Comment discussion: KR Test Fixtures – TP0v

IEEE P802.3ck Task Force

July 6, 2020

Provide editor's view of what the draft would look like if we adopt the proposed TP0v test point and methodology proposed in comments #33 & #153.

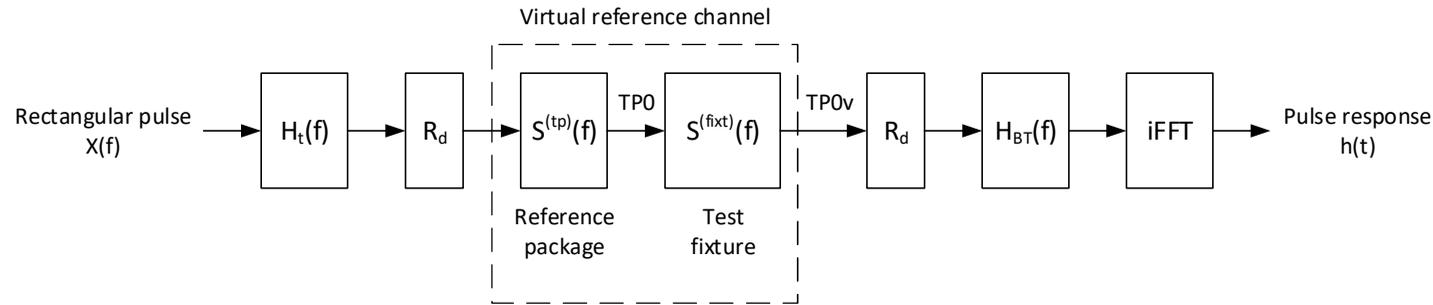
C#	Summary	Notes
31	Increase the TP0-TP0a IL to 2.4 – 3.2 dB @ 26.56 GHz	Current: 1.2-2.4 dB
33	Define new measurement point TP0v, which may vary with implementation.	
34	Specify TP0-TP0v: IL=5 dB @ 26.56 GHz w/ ILD=0.2 dB & specify informative parameters @ TP0a.	http://www.ieee802.org/3/ck/public/20_07/benartsi_3ck_01_0720.pdf
153	Replace test fixture normative requirements with equation-based S-parameters for a 4 dB fixture transmission line & create informative specs @ TP0a. Use new methodology to specify normative requirements.	
154	Eliminate test fixture return loss requirement	
35	Increase loss for Rx test fixture to 3 – 4 dB @ 26.56 GHz with ILD = 0.2 dB.
